Proposed Development
at Ross Rd. Killarney, Co. Kerry

Stage 1 Road Safety Audit

Client	Homeland Group
Project Title	Proposed Development at Ross Rd, Killarney, Co. Kerry
Document Title	Report for Stage 1 – Road Safety Audit
Job No.	25012TT
Document No.	25012TT-Doc01

Figure 2.1

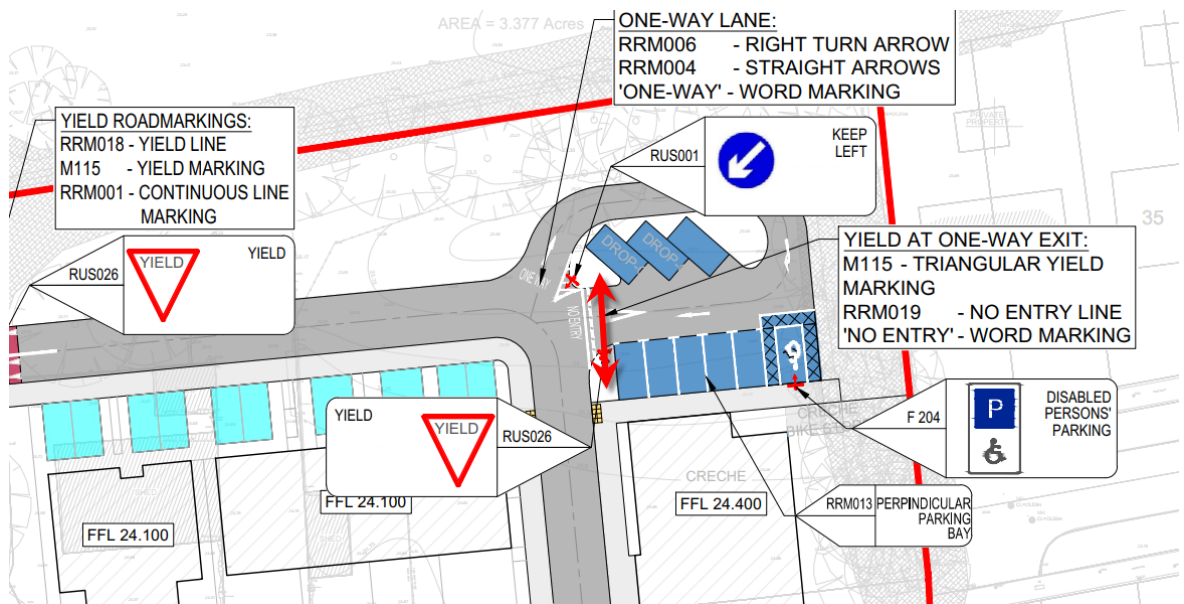
2.1. Problem 1: Pedestrian facilities at Drop-off area at Proposed Creche

The proposed 3 number drop-off parking spaces for the creche do not appear to have a pedestrian connection to the creche building. It is anticipated that young children will be walk from the these parking spaces with their parents to the access door for the creche. Failure to appropriately cater for Pedestrians and vulnerable road users at this location, could lead to conflict and potential collisions between vehicles and pedestrian.

Recommendation 1

Consideration should be given to providing a footpath connection or Pedestrian crossing between the drop off parking spaces and the footpath around the creche.

To be completed by the Designer				To be Completed by Audit Team Leader
Paragraph No. in Safety Audit Report	Problem accepted (yes/no)	Recommended measure accepted (yes/no)	Describe alternative measure(s). Give reasons for not accepting recommended measure. Only complete if recommended measure is not accepted	Alternative measures or reasons accepted by auditors (yes/no)
2.1	Yes	Yes
